NORFOLK VANGUARD AND NORFOLK BOREAS WIND FARM ENGAGEMENT EVIDENCE

STAGE 1B (DESIGN PRINCIPLES) AND 2 A (OPTIONS DEVELOPMENT)

Annex E: STAKEHOLDER ENGAGEMENT EVIDENCE

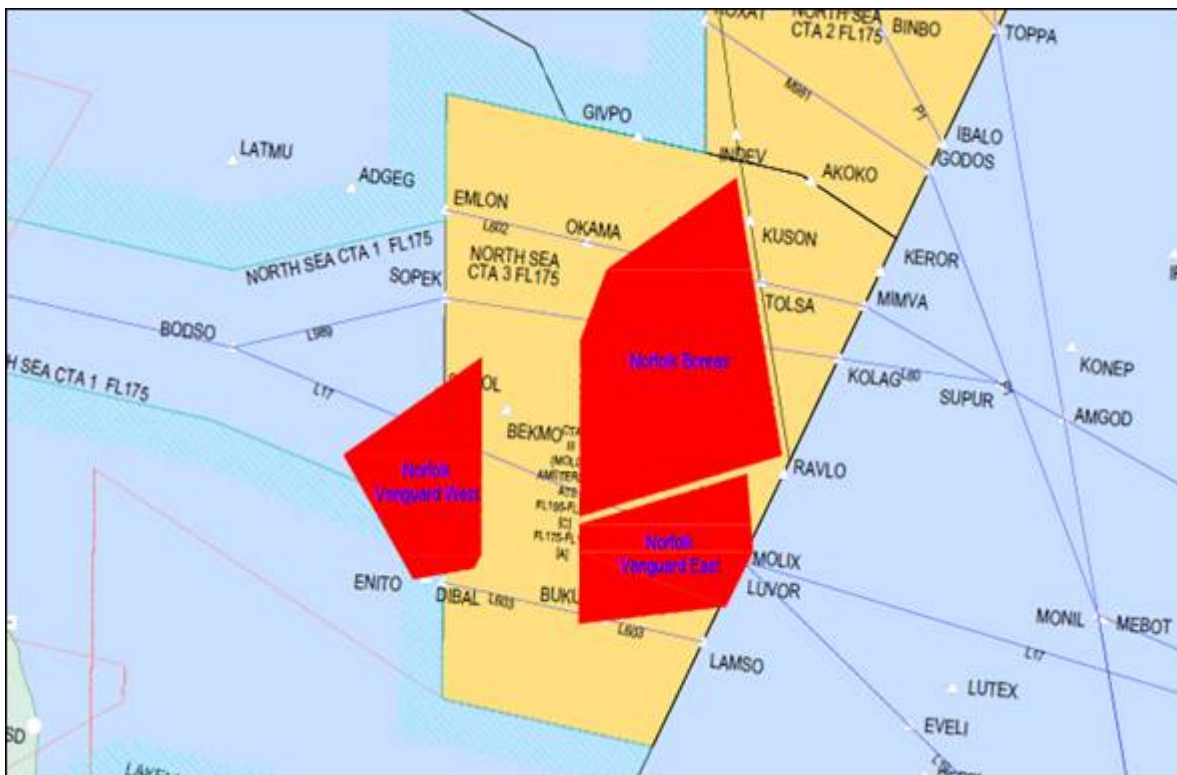
Slight correction to the airspace description below, you mention that some of the airspace in this area is delegated to LVNL (yellow shaded area), this is not entirely correct. The LVNL delegated area does not go all the way to sea level. Anglia Radar provides UKFIS in the yellow shaded area from sea level to FL65 managing the offshore helicopter operation.

Minimise negative impact on other airspace users (ie GA). Also helicopters in support of UK Oil, Gas and Renewables industries.

Airspace change will have minimal impact on operations/capacity of AO and ANSPs. Note – the development could impact on minimum safe altitudes (MSA) used by helicopters in this area.

Minimise environmental impacts to stakeholders on the ground, including the impact of noise below 7,000ft (*note: due to the offshore location of the proposed changes, it is not expected that there will be any significant environmental impacts to stakeholders on the ground due to noise, visual intrusion and local air quality*) Note – if the proposal affects the routings (lateral or vertical) of low level helicopter operations, the environmental aspects (increased fuel burn/ greater CO2 emissions) need to be captured

- This technology could relate to navigation, radar enhancements, radar data processing, etc. might want to change the word 'radar' to 'surveillance' as this would give you more options (e.g. WAM and ADS-B mitigations)

Can we have another technical?

DP12½ Offshore Helicopter Operation

The airspace change will be compatible with the requirements of the offshore helicopter operation supporting the UK Oil, Gas and Renewables industries.
